Harper Canyon (Encina Hills) Subdivision Project
Final Supplemental
Environmental Impact Report
SCH# 2003071157
PLN 000696

December 2024

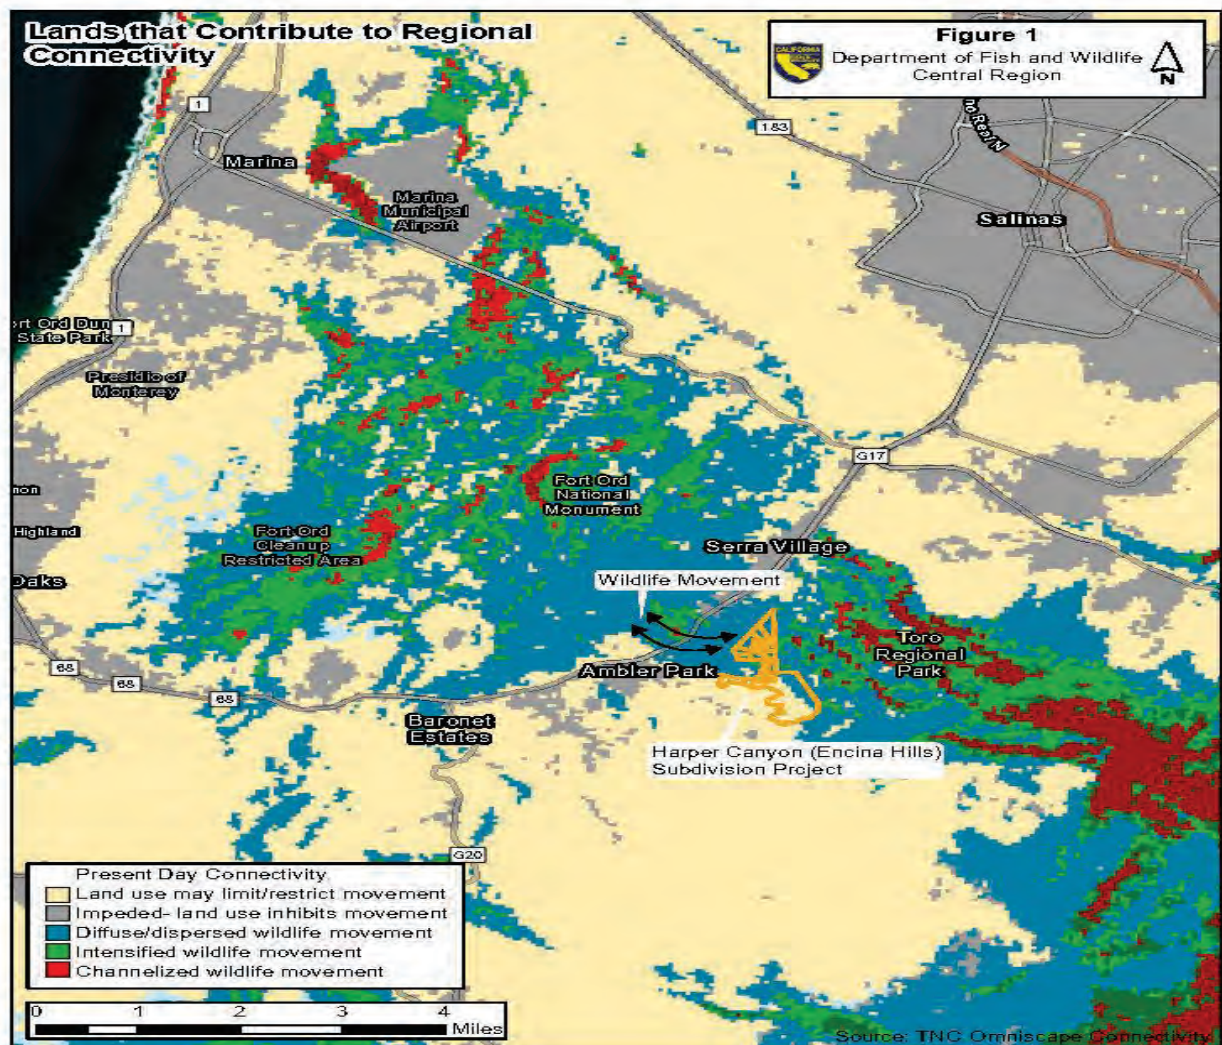
The Project's 17-lot residential subdivision would almost entirely block a primary wildlife corridor between Fort Ord and Toro Park and further isolate Fort Ord and the wildlife species that inhabit the monument (Attachment 1, Figure 1). Attachment 1, Figures 1 and 2, utilize The Nature Conservancy (TNC) Omniscape Connectivity Web Map (TNC 2024) dataset to model wildlife movement within and surrounding the Project site. As Attachment 1, Figures 1 and 2, depict, the majority of the residential subdivision is directly within the sole migratory pathway between Fort Ord and Toro Park. While the SDEIR recognizes the potential impacts to wildlife connectivity associated with the siting of the Project site, and specifically provides mitigation measures to protect a portion of the El Toro Creek corridor, CDFW is concerned that without the protection of the surrounding movement pathways identified in Attachment 1, Figures 1 and 2, the Project would not adequately mitigate for the impacts to wildlife movement.

The comment acknowledges that the mitigation measures identified in the SDEIR protect a portion of the El Toro Creek corridor. However, the comment expresses concern that without protection of the surrounding movement pathways (identified in Figures 1 and 2 of the attachment to Letter E), that project would not adequately mitigate for the impacts to wildlife movement. As stated in this response, the proposed project would provide additional

protection of the surrounding movement pathways by maintaining a 180-acre open space parcel, donating 154 acres of that parcel to expand Toro County Park. Portions of this parcel fall within the diffused/dispersed movement areas, which are those categorized by The Nature Conservancy as areas with high flow (e.g., areas of open space with limited human modification). It should be noted that the other surrounding movement pathways identified as diffused/dispersed movement areas in Figures 1 and 2 include the Fort Ord National Monument, Toro County Park, and Marks Ranch, which are currently protected as open space. Lastly, as a mitigation requirement, corridors through the project site will be identified in the final map where no development shall occur.

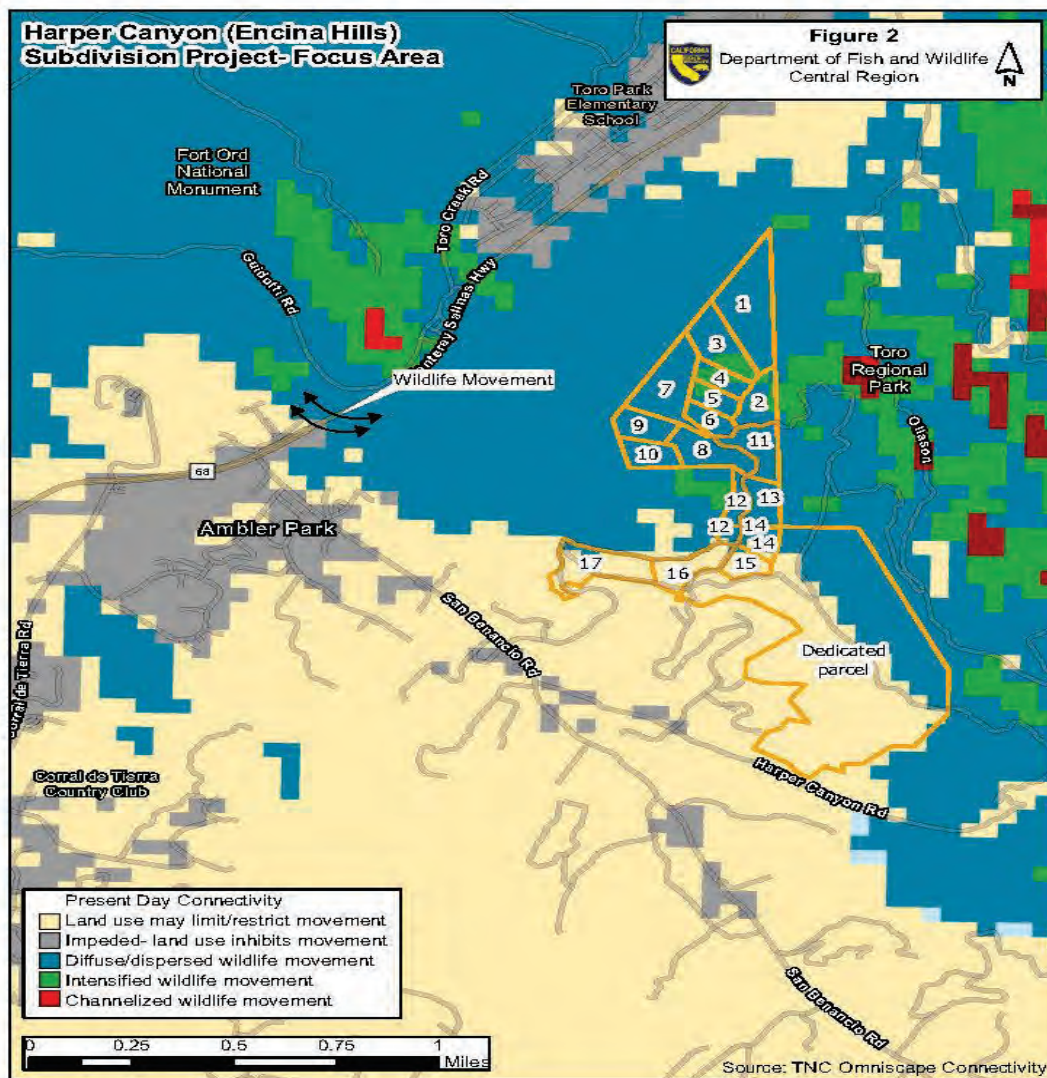
As the proposed Project is likely to significantly restrict wildlife movement between Fort Ord and Toro Park, CDFW recommends the SDEIR be revised and that the Project site be redesigned to allow for a minimum 1.2-mile-wide corridor through the movement areas identified in Attachment 1, Figures 1 and 2 that are within the Project site, to maintain the linkage between Fort Ord and Toro Park. This corridor width recommendation follows the recommendations noted in the South Coast Missing Linkages Project (Penrod et al., 2006), a project focused on finding missing linkages, or corridors, in southern California, which notes that a minimum 1.2 miles width allows, “For a variety of species [...] a wide linkage helps ensure availability of appropriate habitat, host plants (e.g., for butterflies), pollinators, and areas with low predation risk.

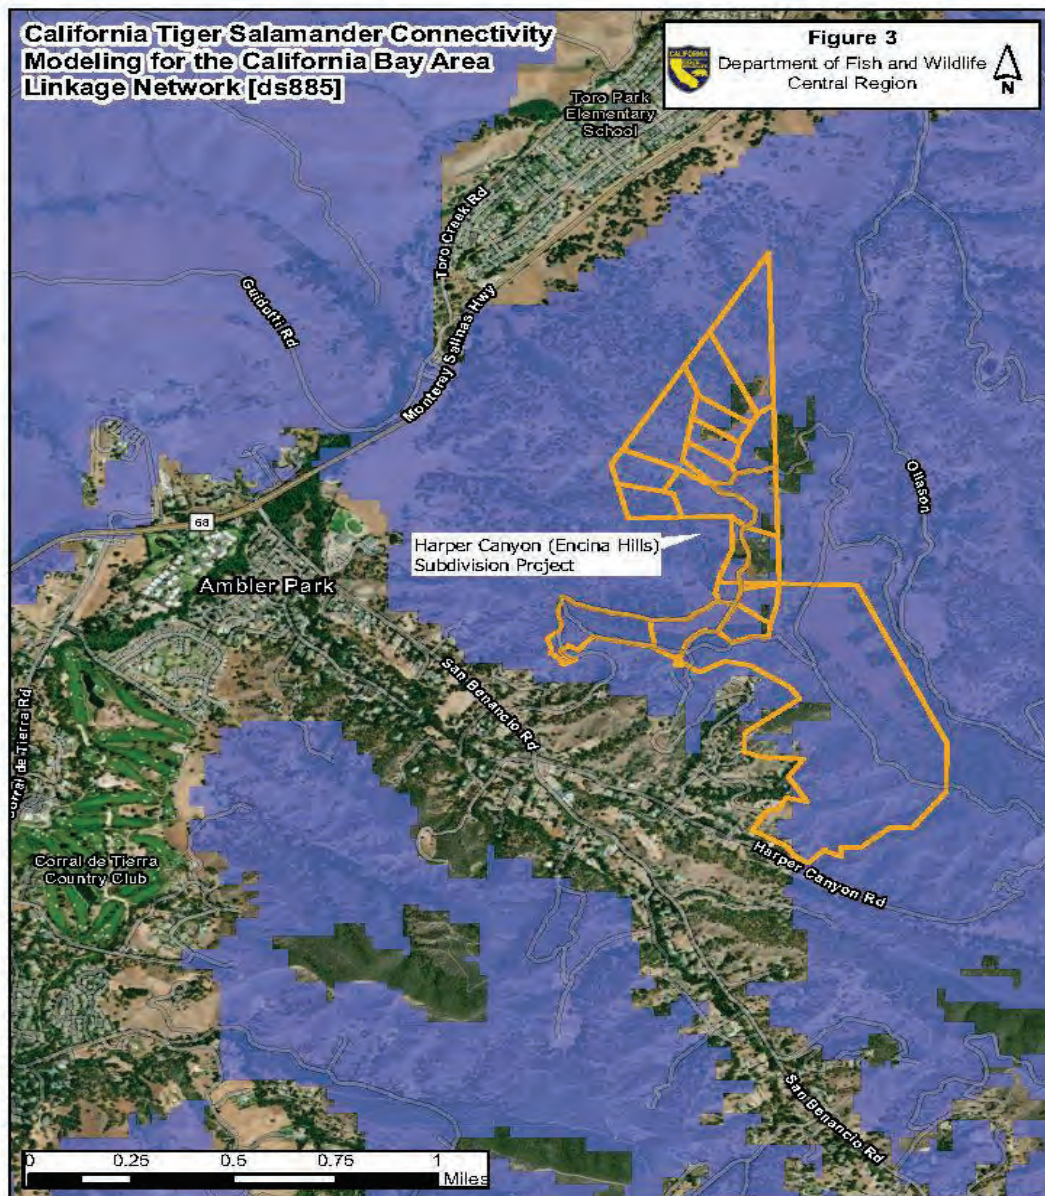
The Project site is within the known range of CTS and contains suitable habitat for the species, and CTS have been documented within both Fort Ord and Toro Park (CDFW 2024). Additionally, it does not appear that CTS surveys have been conducted since 2012, and the original surveys were potentially not adequate to detect CTS. CDFW would like to highlight the importance of the Project site for CTS connectivity, movement, and breeding. Attachment 1, Figure 3 illustrates potential areas of breeding habitat for CTS within the Project site. The highlighted areas (i.e., blue areas) within Attachment 1, Figure 3, depict (similarly to Attachment 1, Figures 1 and 2) that the Project is within an essential linkage area between Fort Ord and Toro Park for CTS breeding and movement. Any development within the Project site would likely limit genetic diversity and gene flow, impact the resiliency of CTS populations, and potentially impact entire CTS populations over time.
